Twin Falls Historic Preservation Commission Agenda

Date: Monday, August 3, 2026
To: Historic Preservation Commission
From: Lisa Strickland, City Planner

Request for a Certificate of Appropriateness for exterior windows and doors on property located at 250 Main Avenue North. (PZ26-0087)

Request for a Certificate of Appropriateness for proposed new signs on property located at 147 Main Ave E. c/o Lytle Signs on behalf of Verin Properties, LLC PZ26-0095

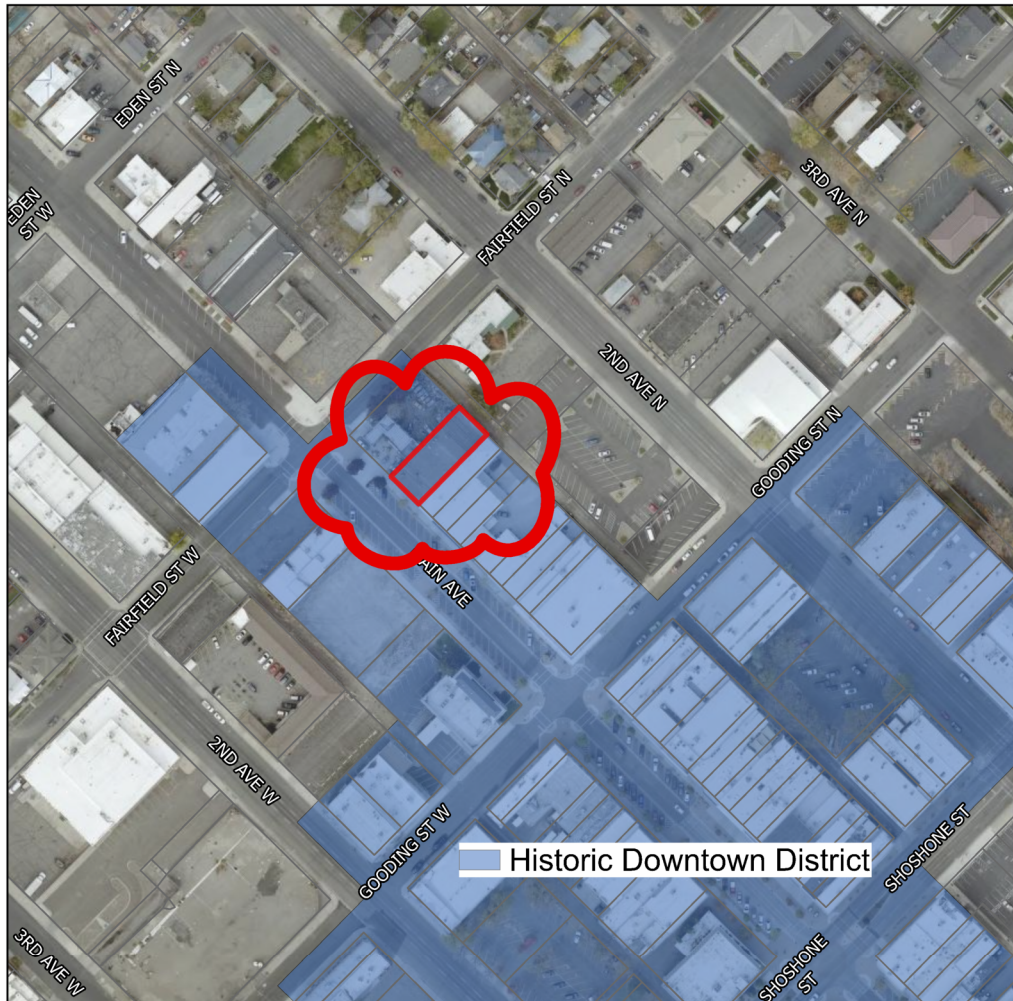
The proposed rear elevation windows are currently obscured by plywood. The proposal is to remove the

plywood and restore the windows with a compatible style and material that doesn't detract from the character of the building. The window style proposed have a narrow profile and are divided a typical style for the time period of the building. The change will preserve the original masonry wall, and retain the historic openings. The change should have minimal impact on the original construction and does not create a false historical appearance. The proposed new windows could be considered compatible with the guidelines and appropriate for a rear elevation.

1. Subject to site plan amendments as required by City Code Standards.
2. Subject to the applicant obtaining permits as required by City Code Standards.

Request # 1 - Rear Door Sign

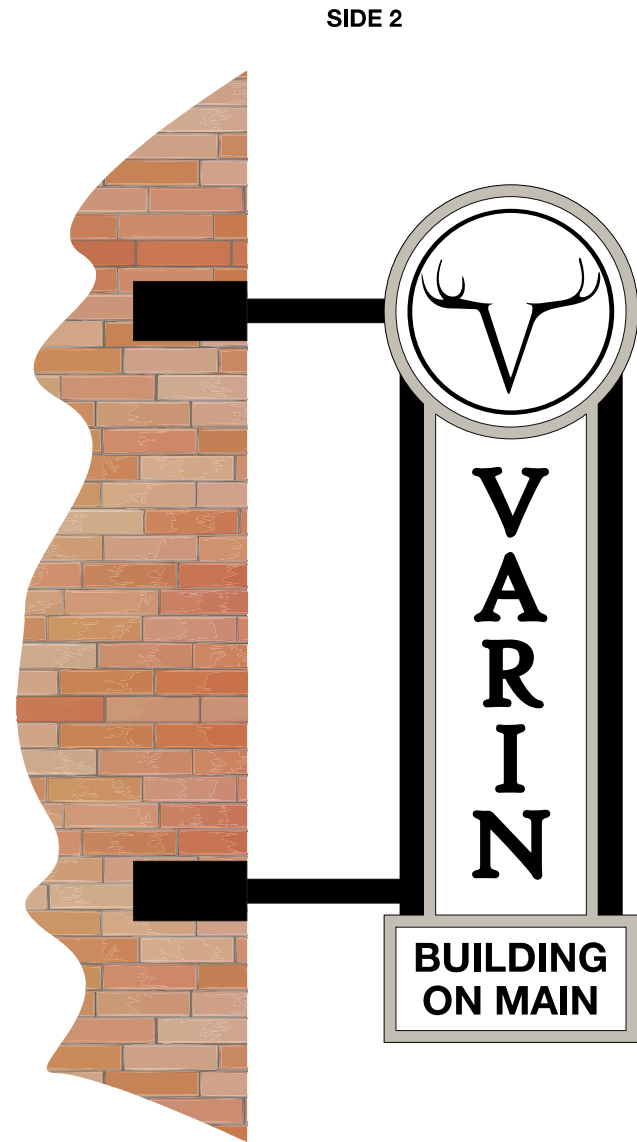
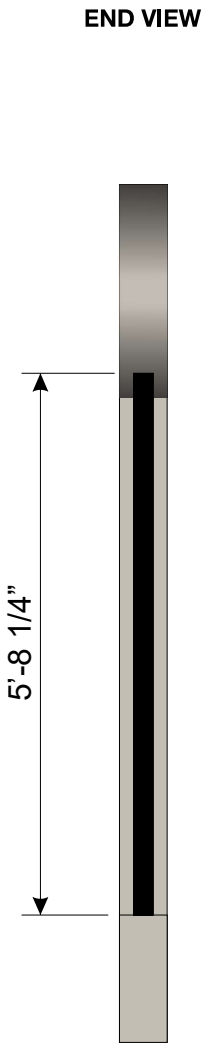
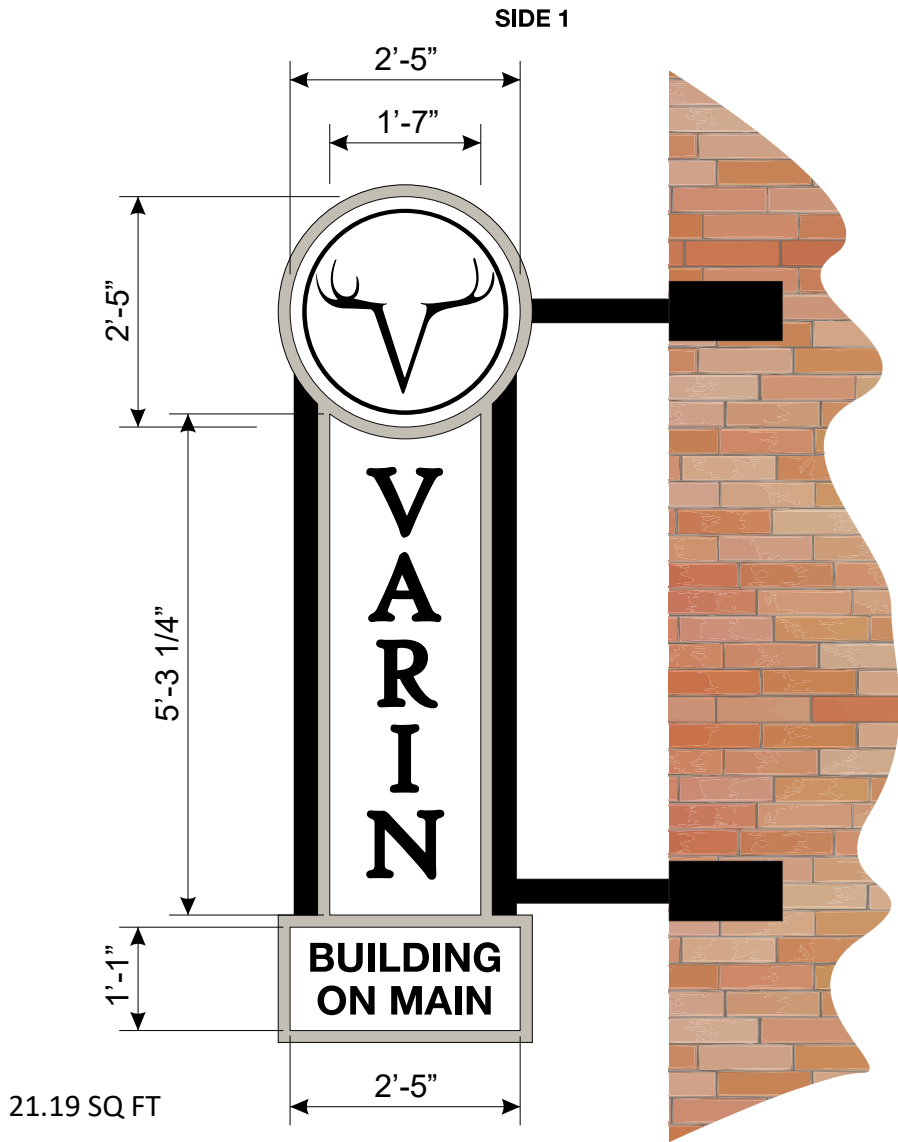
1- Rear Door

The request is to remove the existing vinyl address from the rear door of the building and to be replaced with a new vinyl sign. The "Var Inn" will be the new sign placed on the back entrance to the buildings. The size, design, materials and location of this sign are appropriate and will not detract from the building's facade or architectural features. The proposed sign could be found to be compatible with the guidelines.

Request # 2 - Projecting Front Sign

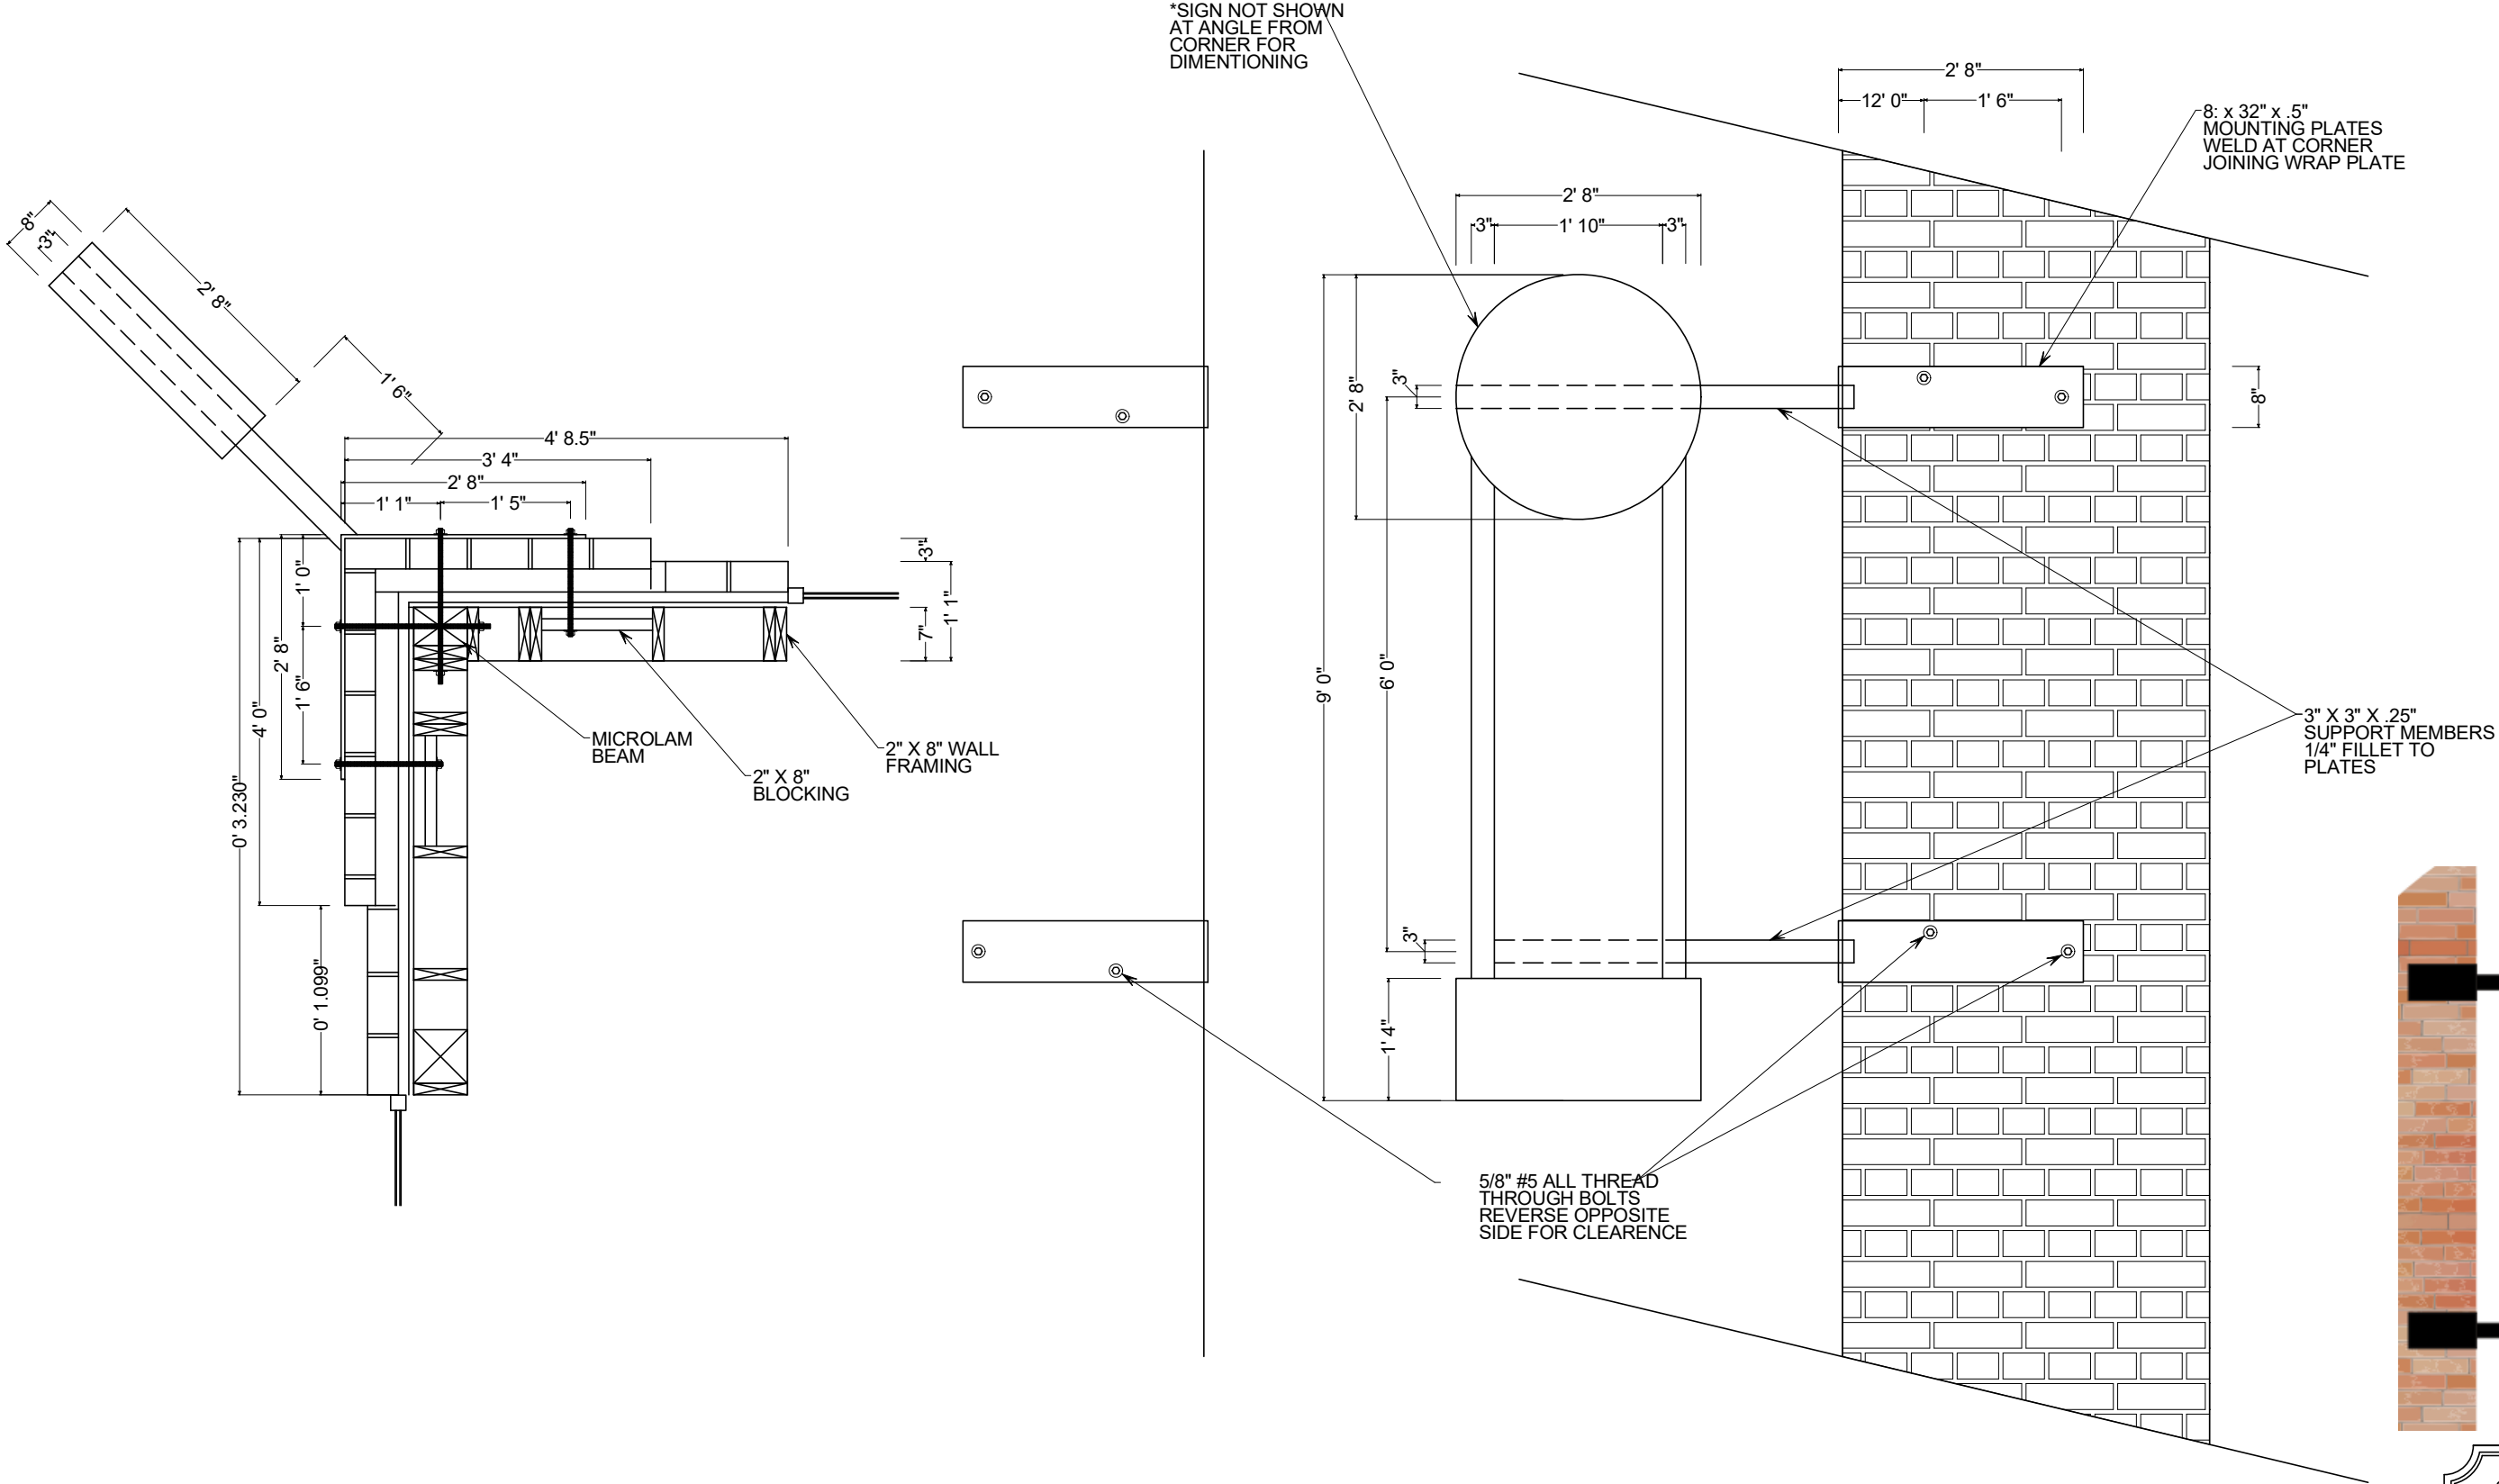
2- Projecting Sign

This request is to replace the face of the front projecting sign with a new face. The existing projecting sign is was approved with a Certificate of Appropriateness in 2022. The change will reflect the new owners name "Varin". This is a minor change and does not require any structural changes to the existing frame. The colors and material of the proposed face are characteristic of other signs within the district. The proposed sign could be found to be compatible with the guidelines.

Request # 3 - Identification Block

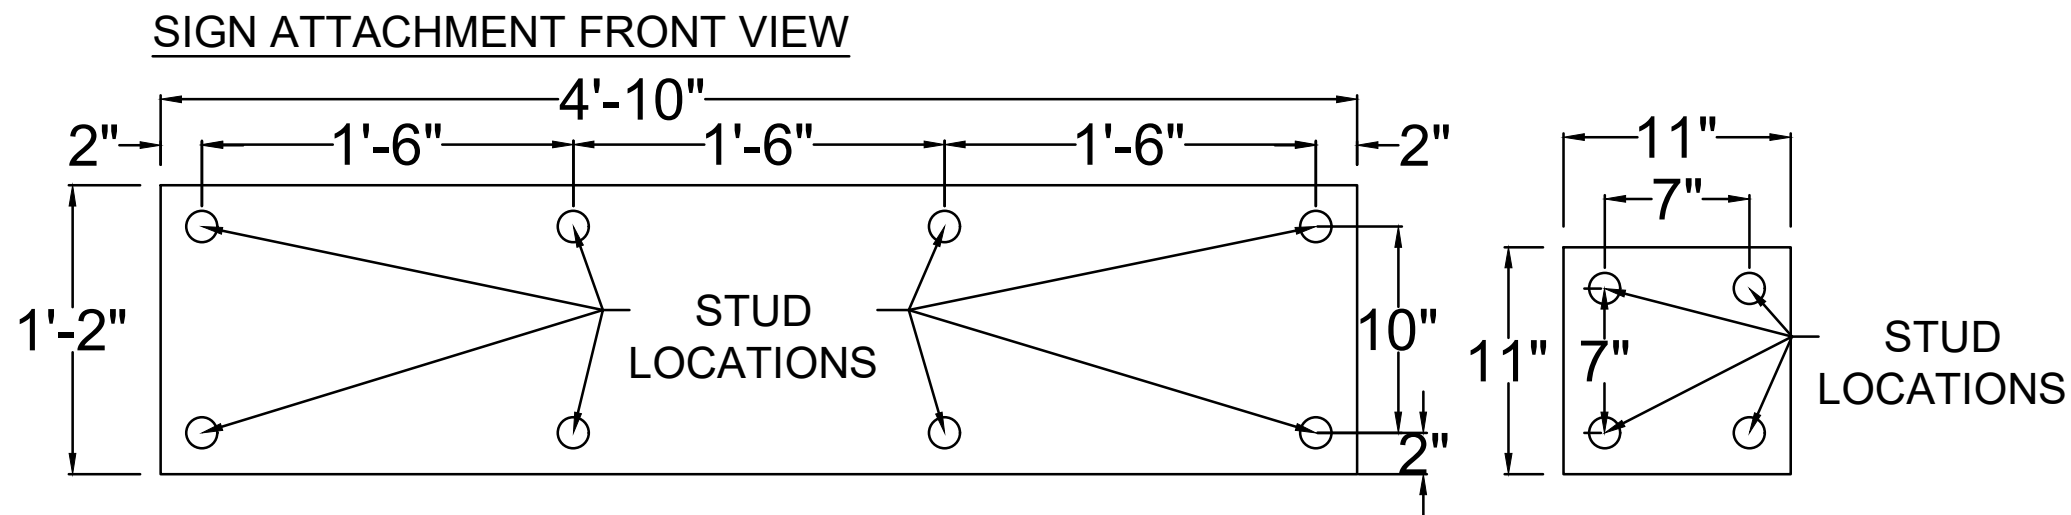
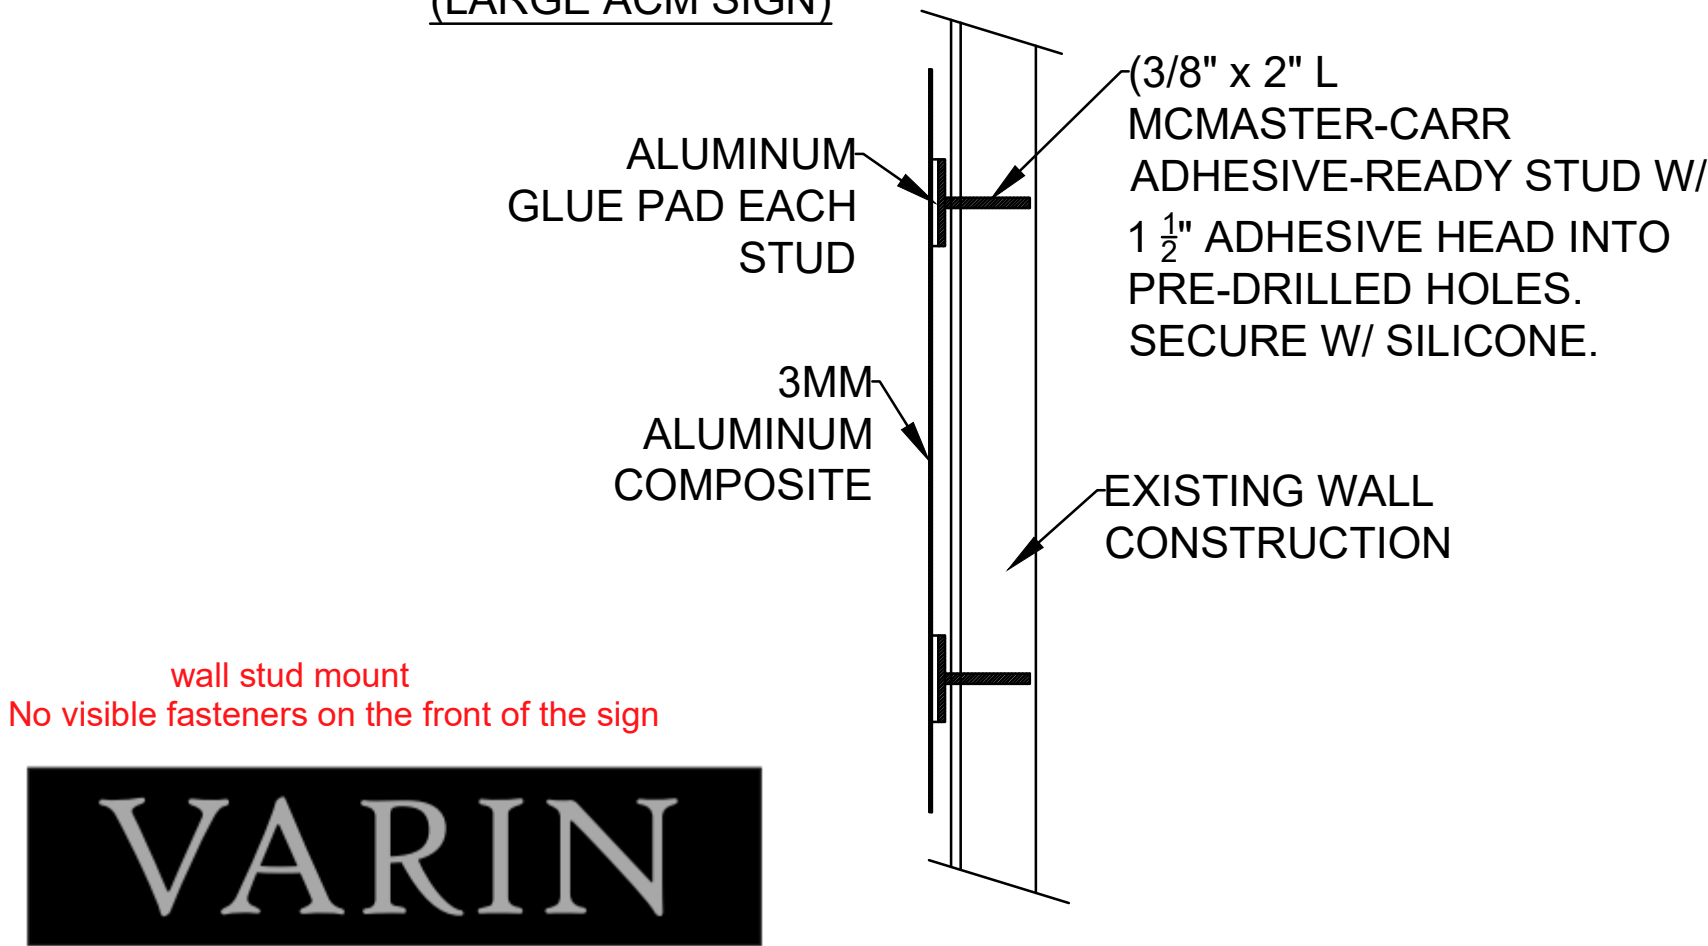
3-Identification Block

The third change proposed by the applicant is to cover the existing engraved building name "Gate" with an aluminum composite material with the name "Varin". Debra Gates is responsible for the design of the current building that was approved for a Certificate of Appropriateness in 2017. An elevation of the proposed changes has been provided in the packet. As part of the approval the name "Gates" was intended to be a permanent architectural feature of the building. The proposal to cover this architectural feature is not a sign change it is an alteration to a character defining element. The name was intended to give the building an identity, not to identify a business operating in the building. While the building is non-contributing, the Historic Guidelines still encourage preserving architectural features that define the building. Concealing this architectural feature could be considered inappropriate based on the Secretary of Interior Standards that discourages obstructing or removing architectural features. This change could be found to be incompatible with the guidelines.
